**CENTER FOR DRUG EVALUATION AND
RESEARCH**

209988Orig1s000

PRODUCT QUALITY REVIEW(S)

NDA Executive Summary

Figure 2: SAC Top Level Structure

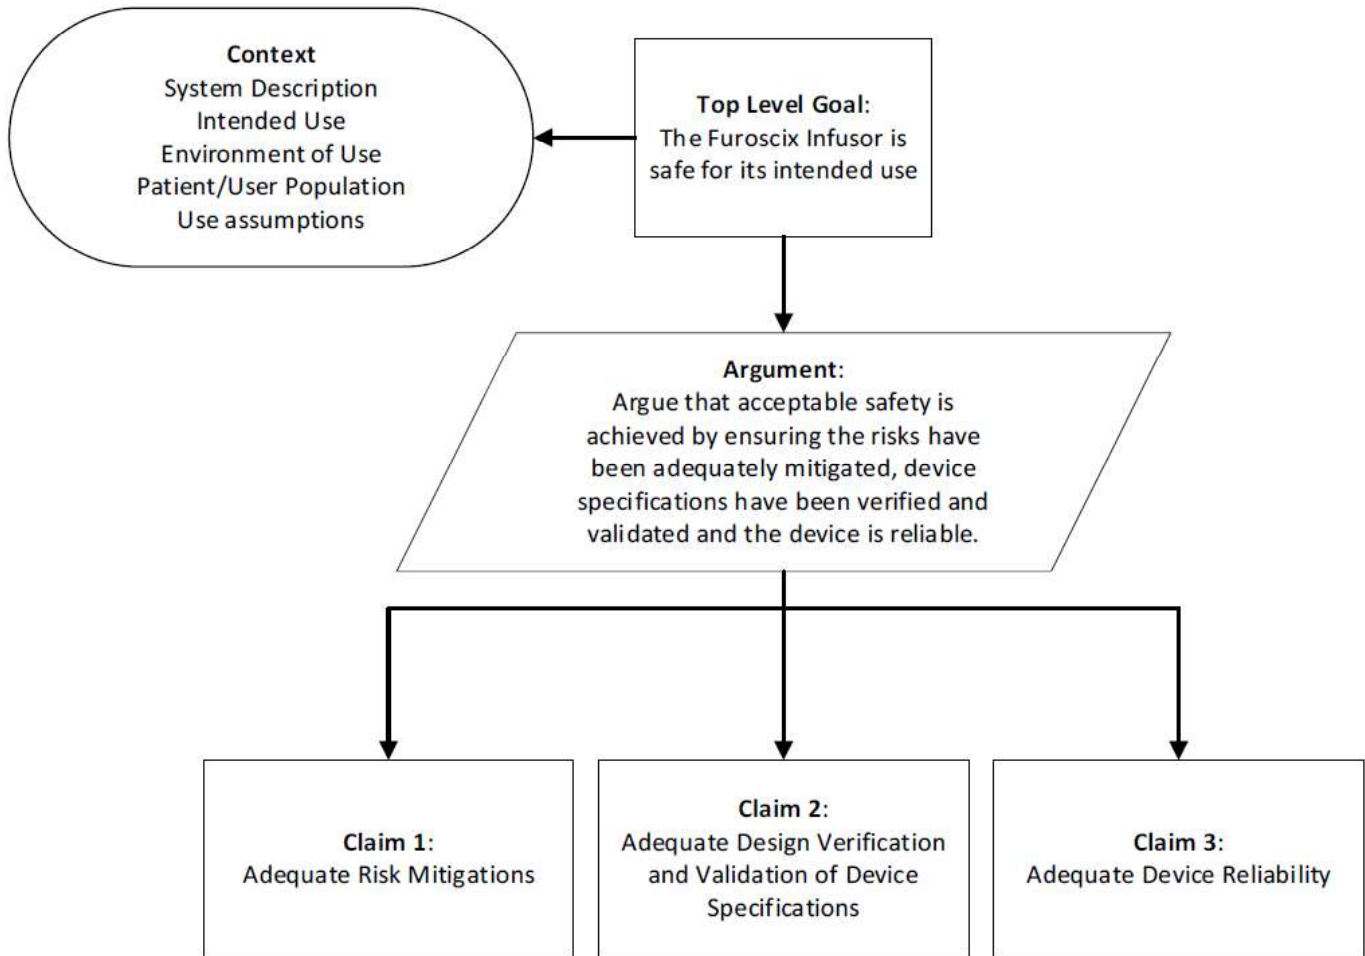
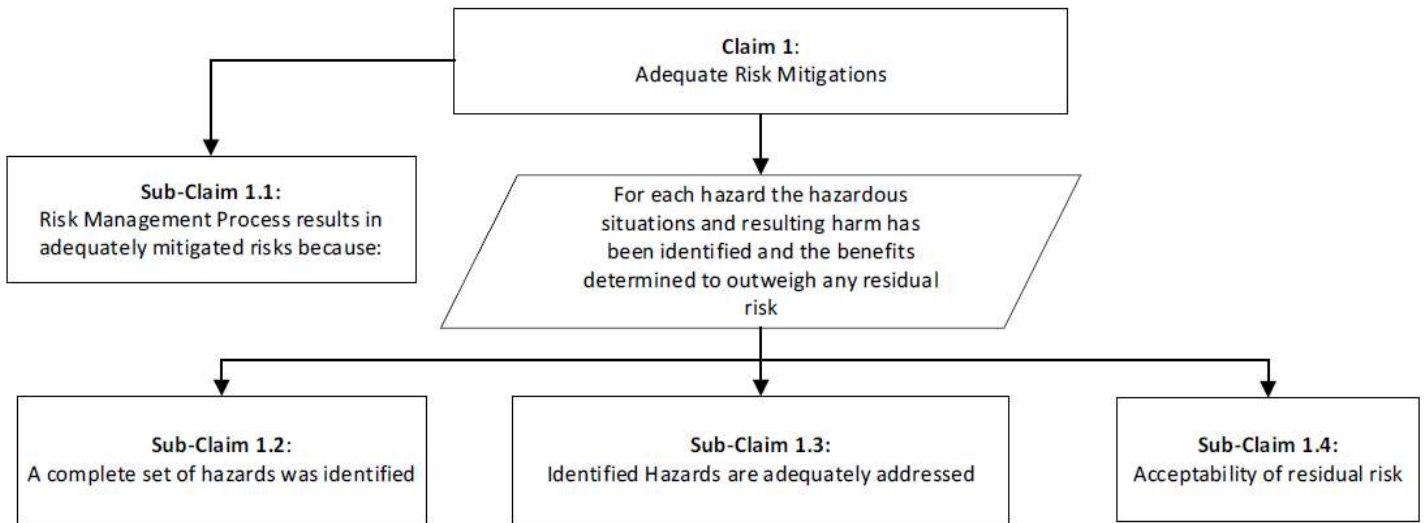
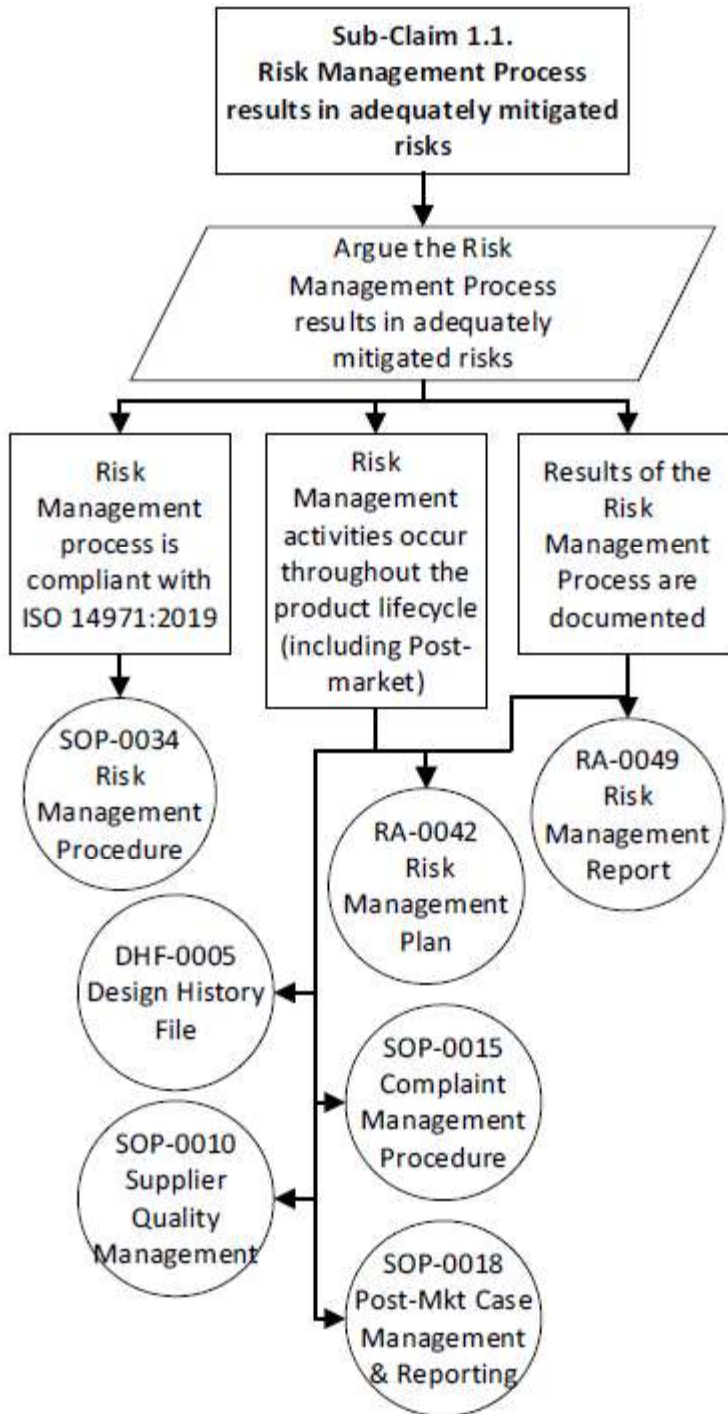
The sponsor's SAC structure is acceptable. The top level structure and then examples of claim-argument-structures and sub-structures are included below.

The sponsor has adequately linked goals, claims/sub-claims arguments to evidence to support them.

Figure 4. Histogram of delivered volume accuracy test results

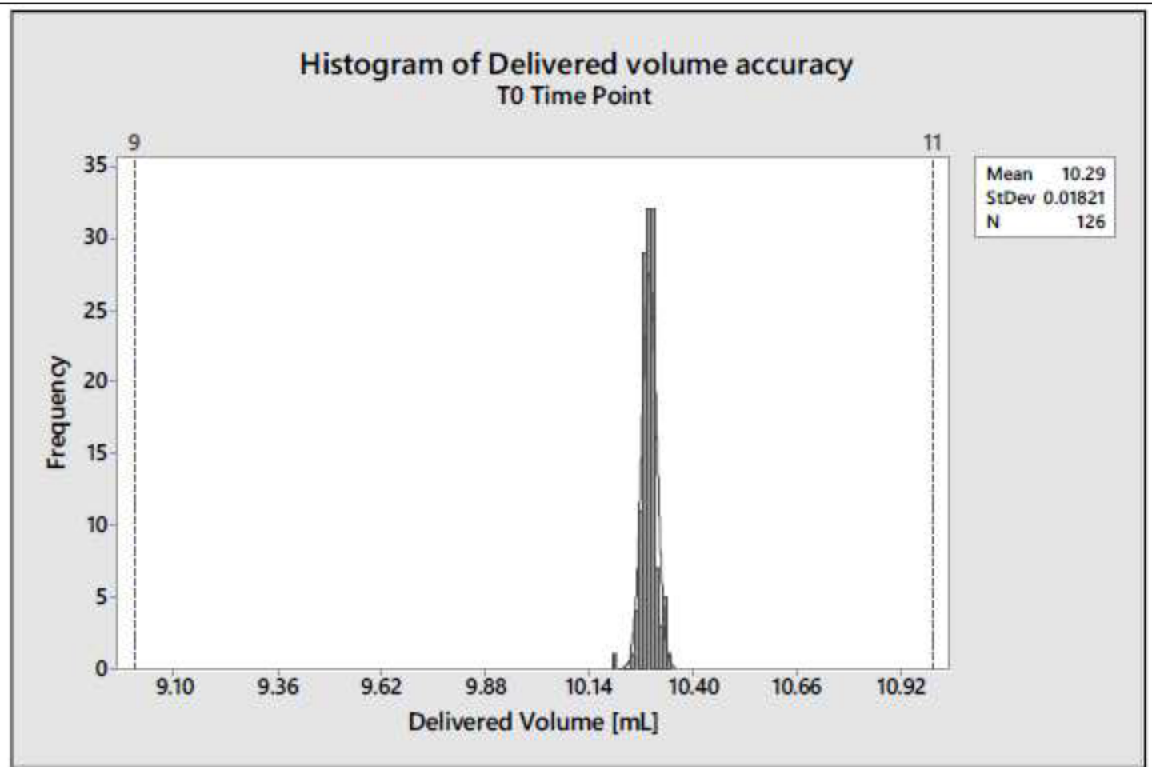
Conclusions/ [Reviewer Comments](#):

Figure 7. Histogram of flow rate accuracy test results

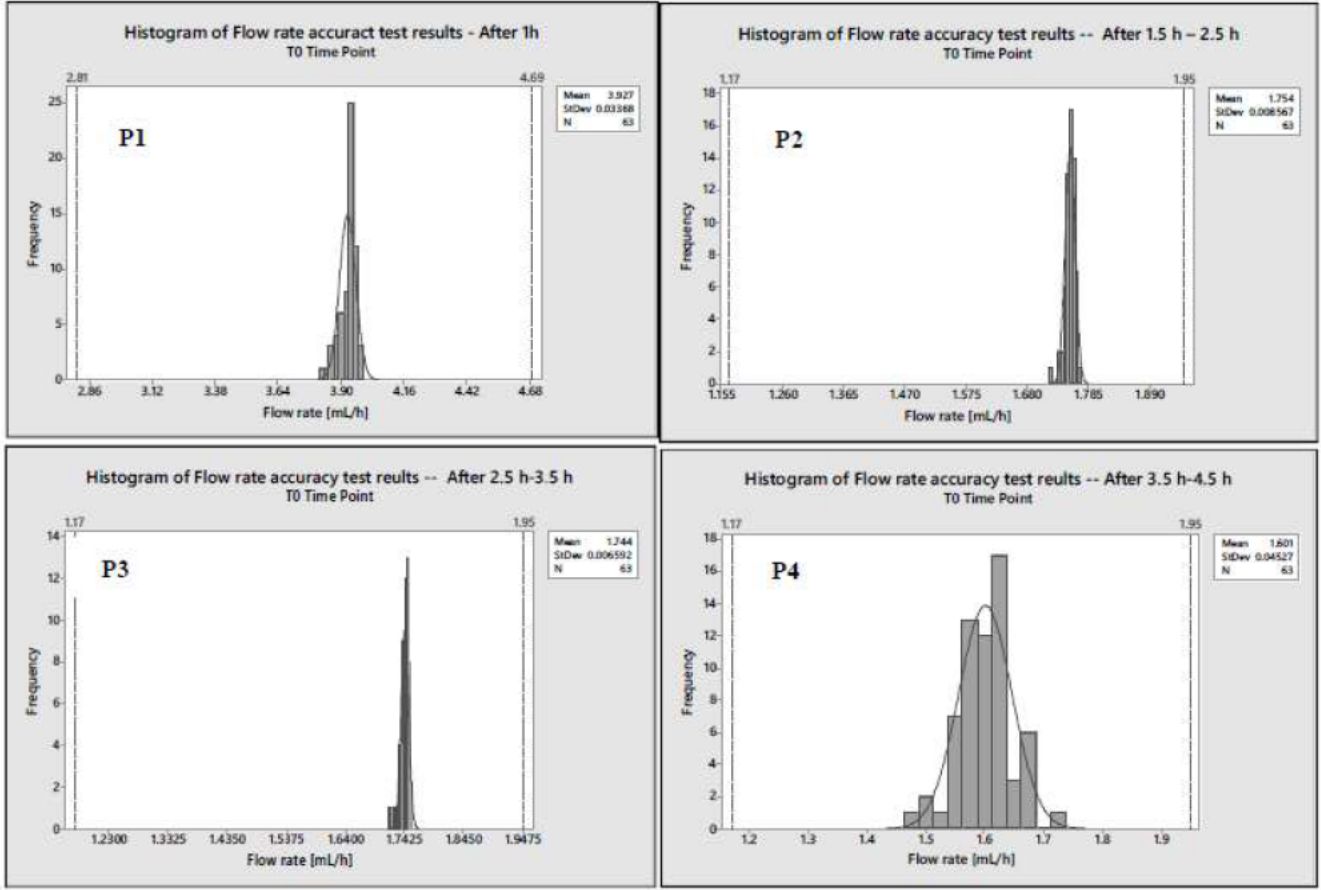
Conclusions/ [Reviewer Comments:](#)

Figure 3: Dose Delivery Reliability results from Design Verification Report (b) (4)

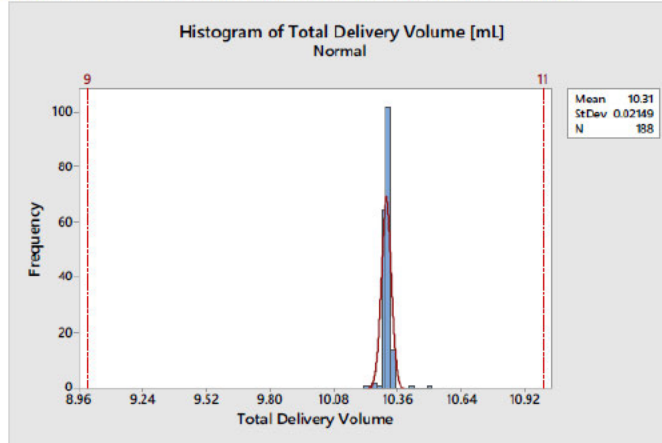
Figure 3 represents the results from the dose delivery reliability test for time point t=0 from West report (b) (4). Results show a very tight distribution with reference to the specification limits.
